Comment discussion: KR Test Fixtures

IEEE P802.3ck Task Force

June 30, 2020

Comments (Full Text)

Test Points

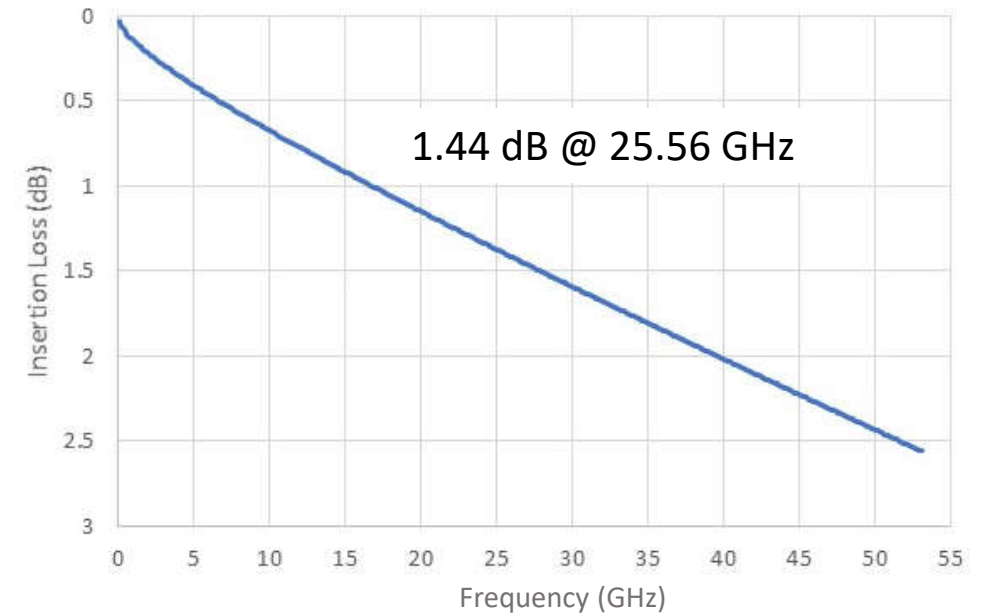
- TP0 @ Package ball; TP0a: test fixture
- 163.9.1.2 specifies range 1.2 – 1.6 dB
- Effects of differences between test fixture IL & ref IL are to be accounted for in measurement

- C#31: Change IL range to 2.4 – 3.2 dB @ 26.56 GHz
- C#33 & #34: Specify TP0v with IL = 5 dB @ 26.56 GHz and ILD = 0.2dB. Keep informative TP0a specifications.
http://www.ieee802.org/3/ck/public/20_07/benartsi_3ck_01_0720.pdf
- C#153: Specify S-parameters for 4dB fixture transmission line, along the lines of Equation 93a-14.

Enabling implementation-dependent test fixture

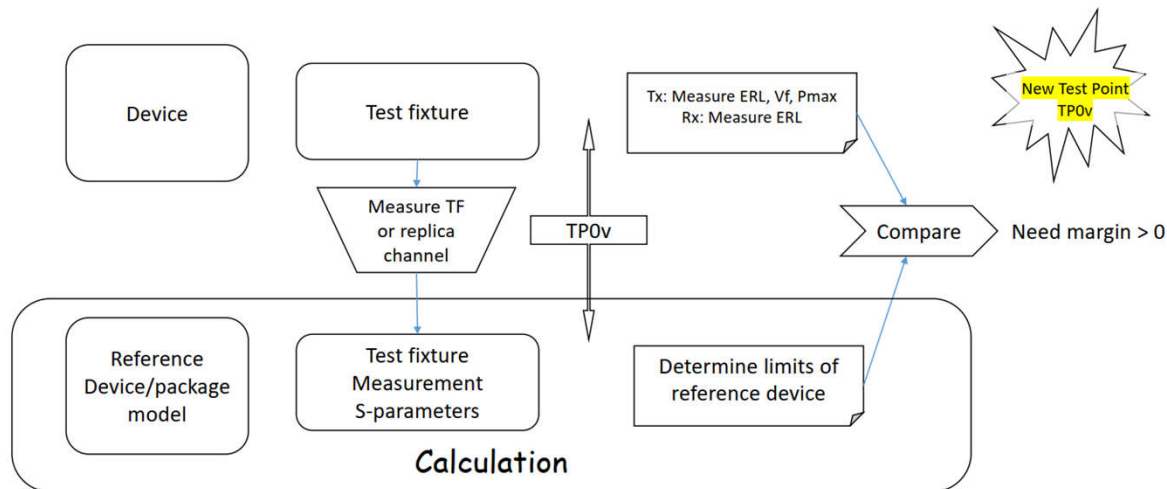
- ❑ As presented in [mellitz 3ck 01a 0120](#)
 (“Practical Device Test Fixtures for 100G KR ... or Not and the Impact on ERL and P max /V f”)
 - Test fixtures introduce offset and variability
 - Accounting for practical test fixture variability test dwarfs the limit we would want set
 - Recommend: Specify transmitter at a TPO and receiver at TP5

- ❑ Measure TPO-TPOv channel (or replica) for the device/lane under test
- ❑ Concatenate Tr filter, Tx reference device and package model, and B-T measurement filter (same equations used in COM)
- ❑ Using the concatenated channel, calculate an output pulse response (with minimum A_v) and TDR at TPOv, with ideal termination
- ❑ Calculate Vf, Vpeak/Vf, and ERL
 - The results are the expected parameters of the reference Tx at this TPOv
 - This is the bar that the DUT should be compared to!
- ❑ Now measure Vf, Vpeak, and ERL of the DUT at TPOv using existing method
- ❑ Margin from the calculated reference values → pass/fail
